**From:** [REDACTED]  
**To:** [REDACTED]  
**Sent:** 2/24/2021 9:16:37 AM  
**Subject:** RE: O8W-PM 35217268, 35224712, 35224713 - Bucks Creek 1101 Phase 1,2&3 - Pre-Engineering Meeting

PM 35217268 (Phase 1)

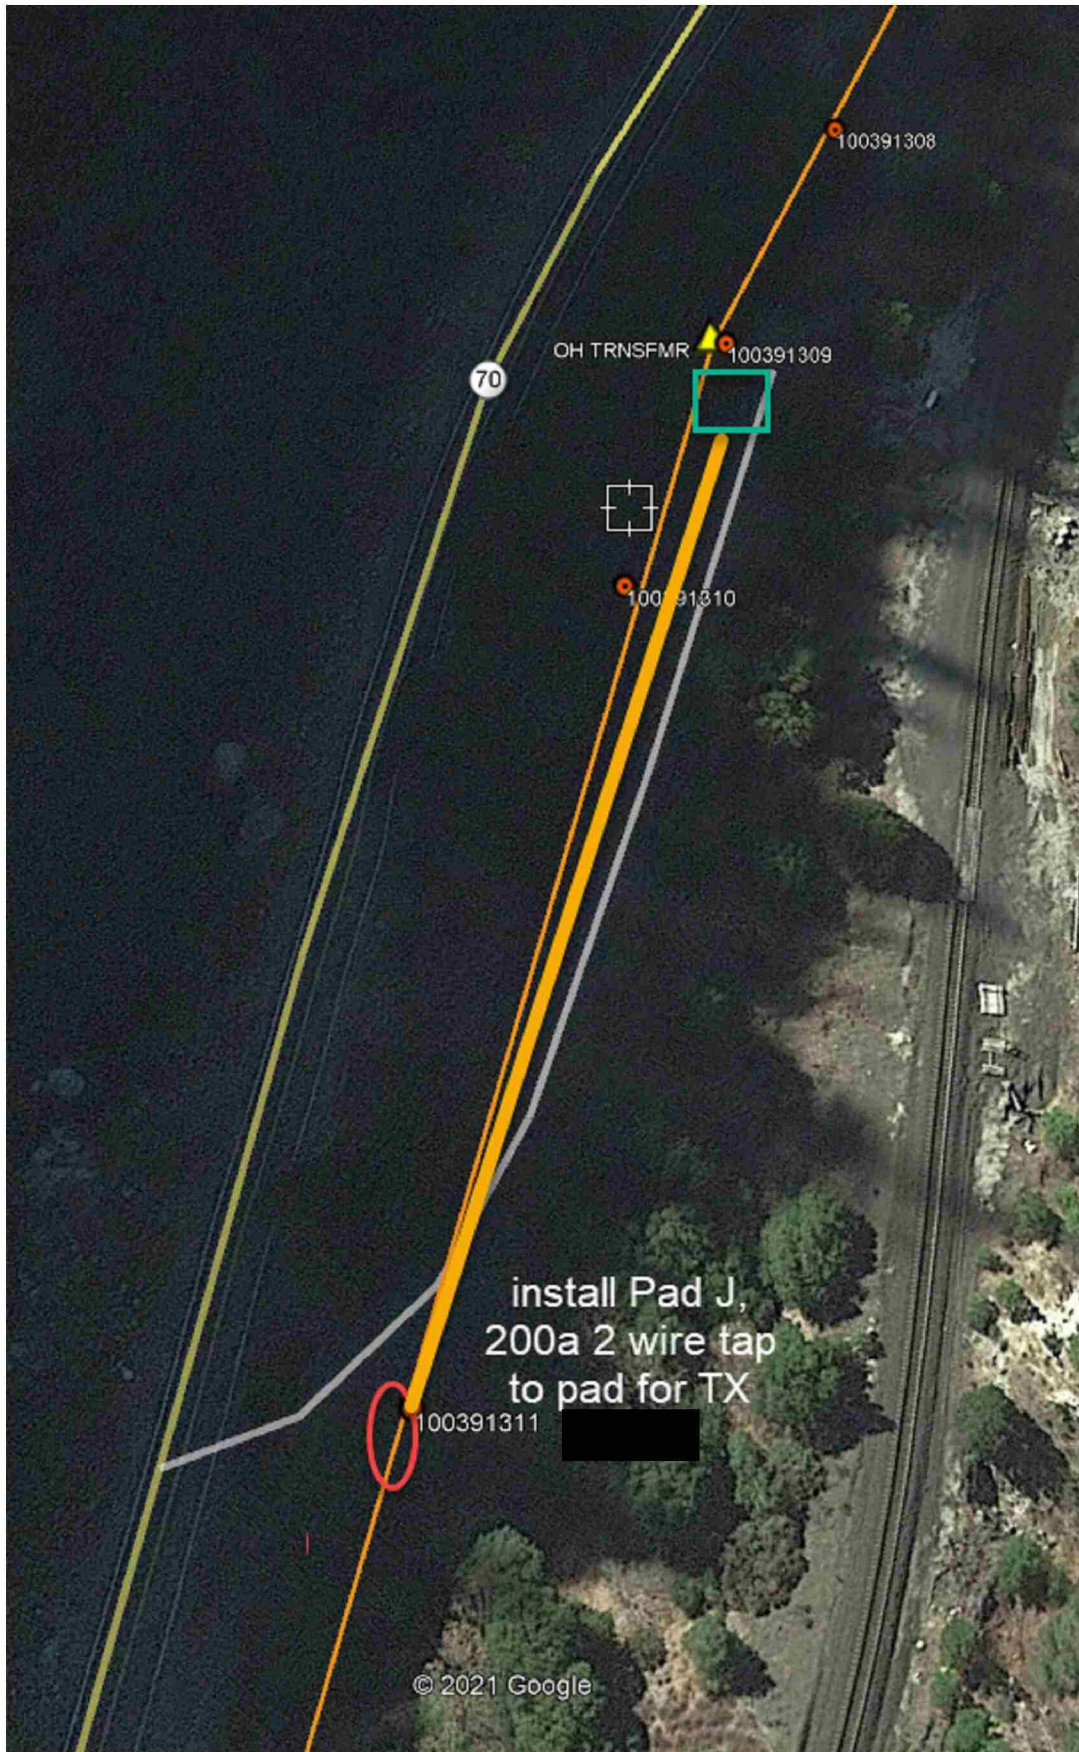
Also need to see what Hydro is willing to do with the TX for the penstock metering valve at Rock Creek PH. It will be a long way up from the

Need to see if Hydro has GPR data for the Hwy 70 road bed to see if we can get 42" minimum cover and keep clearance over any hydro facilities.

Merlin can go back like we just did [redacted] Poe. Pad on the Highway and tension secondary 1/0 ASCR across the river. We can negotiate to move the [redacted] service point with my MSA electrician.

we can serve [blacked out] Merlin with either circle, OH 1/0 ASCR triplex tension across the river.

Should be able to take a pad here and get the dam a UG service. For [blacked out] riser up and go in the back of

the first tunnel window, leave the old TX pole, top it and use to splice in UG service feed.
